Access Compliance Report Public Rights-of-Way (Curb Ramps)

Intersection ID: 20834 Main Street: COLONY_CROSSING_DR Cross Street: COLONY_RD Location: SE

ADA ID: 6EBC2CEFED3C Ramp Type: Directional1 Initial Pass/Fail: Fail Overall Compliance: No Severity Score: 12.5

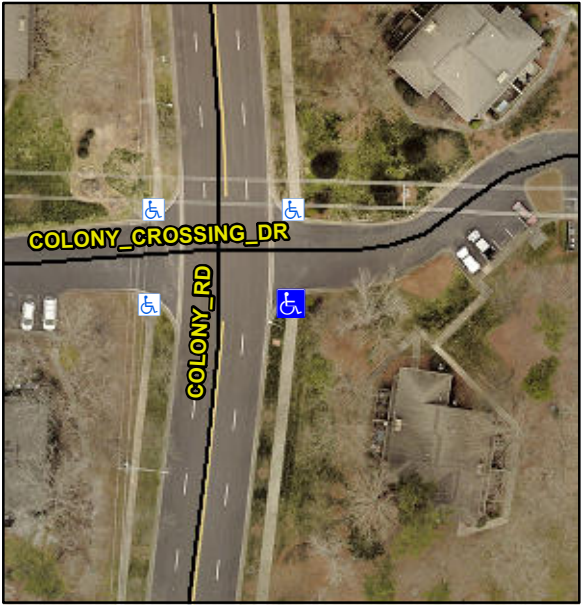
PROW/ADA:
R304.5.3

Compliance	Description	Data	Compliance	Description	Data
N/A	Ramp Length (in)	76.0	N/A	Grade Break?	N/A
Yes	Ramp Width (in)	72.0	N/A	Grade Break Slope (%)	0.0
Yes	Ramp Slope (%)	3.9	N/A	Grade Break XSlope (%)	0.0
No	Ramp XSlope (%)	5.1			
N/A	Flare Type LT	N/A	N/A	Flare Type RT	N/A
N/A	Flare Slope LT (%)	N/A	N/A	Flare Slope RT (%)	0.0
N/A	Flare Traversable LT?	N/A	N/A	Flare Traversable RT?	N/A
N/A	Landing Length (in)	0.0	N/A	DWS Provided?	N/A
N/A	Landing Width (in)	0.0	N/A	DWS Contrast?	N/A
N/A	Landing Slope (%)	0.0	N/A	DWS Length (in)	N/A
N/A	Landing X Slope (%)	0.0	N/A	DWS Full Width?	N/A
N/A	Landing Curb? (Y/N)	N/A	N/A	DWS Offset LT (in)	N/A
N/A	Shared Landing?	N/A	N/A	DWS Offset RT (in)	N/A
N/A	Gutter Ponding?	0.0	N/A	Gutter Slope (%)	N/A
N/A	Gutter Lip Ht (in)	0.0	N/A	Gutter X Slope (%)	N/A
N/A	Painted X Walk1?	No		Road Slope (%)	7.8
	X Walk 1 Direction	To NW		Road X Slope (%)	6.5
	X Walk 1 Width (in)	N/A		Clear Space?	N/A

Possible Solutions:
Remove & Replace Entire Ramp.
